SUBJECT: AMENDMENT OF SOURCE MATERIALS LICENSE SUA-56 TO MODIFY THE GROUND-WATER AND SURFACE WATER MONITORING PROGRAMS AT WESTERN NUCLEAR, INC.'S SPLIT ROCK SITE, AMENDMENT 98 (TAC LU0083)

TECHNICAL EVALUATION REPORT FOR
WESTERN NUCLEAR, INC.'S MODIFICATIONS TO THE GROUND-WATER AND SURFACE
WATER MONITORING PROGRAMS AT THE SPLIT ROCK SITE, JEFFREY CITY, WYOMING

Figure 1 - Ground-Water and Surface Water Sampling Locations (WNI, 2005)

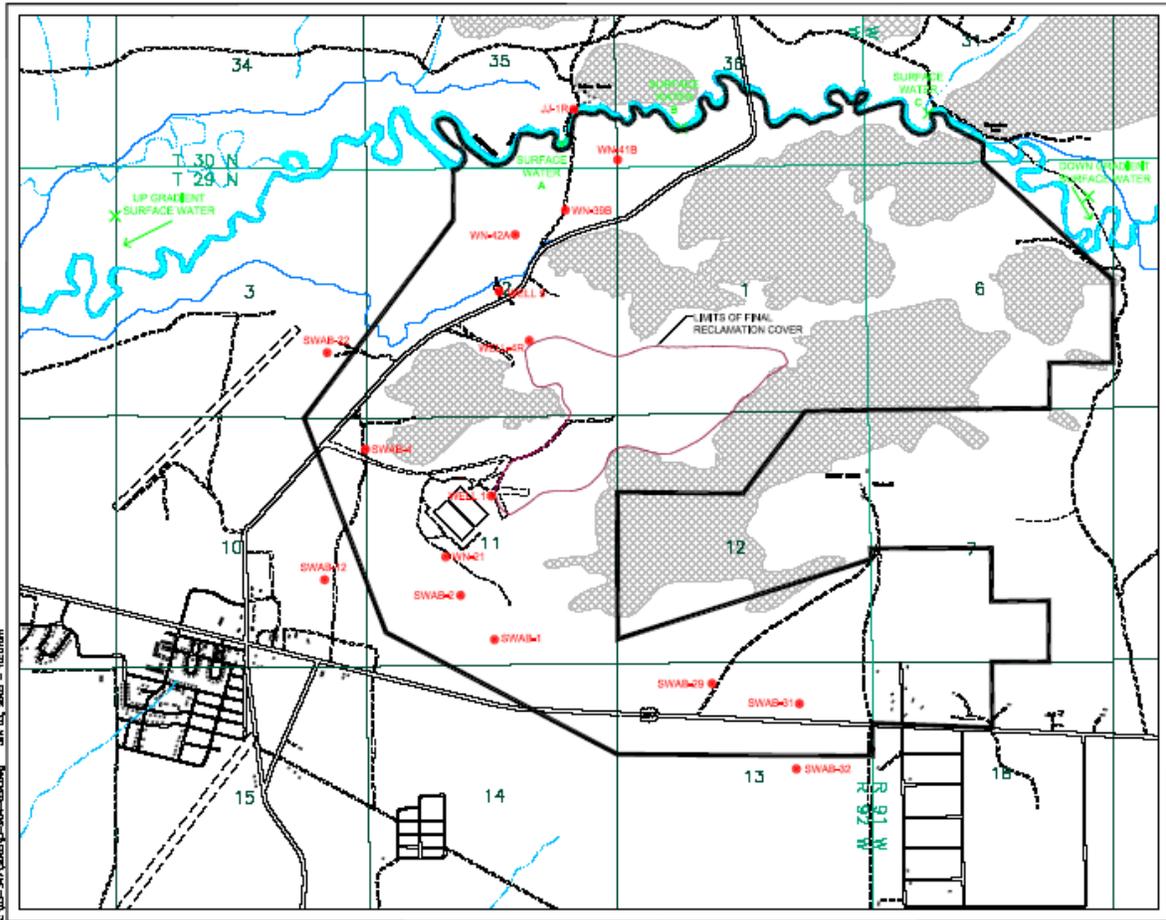
On November 10, 2004, and January 18, 2005, the NRC provided comments regarding this monitoring network, suggesting that seven more wells be added and that all wells be sampled semi-annually for the full list of parameters. NRC staff suggested that two wells could be removed from the program after approval of the ACL application. On March 2, 2005, WNI submitted a revised ground-water monitoring plan. This plan included all the requested wells; however, WNI stated that it would sample two wells for the full parameters list and the remaining wells for uranium and sulfate only. Figure 1 presents the monitoring network subject to this TER.

On May 17, 2005, NRC staff and WNI discussed the discrepancy in the monitoring plan and came to a final agreement. WNI would sample wells 1, 21, 4R, and 5 for the complete suite of analytes proposed in the May 24, 2004, license amendment request. The remaining wells would be sampled semi-annually for uranium, sulfate, and water levels and annually for the complete list of analytes. Table 1 summarizes the sampling program subject to this license amendment.
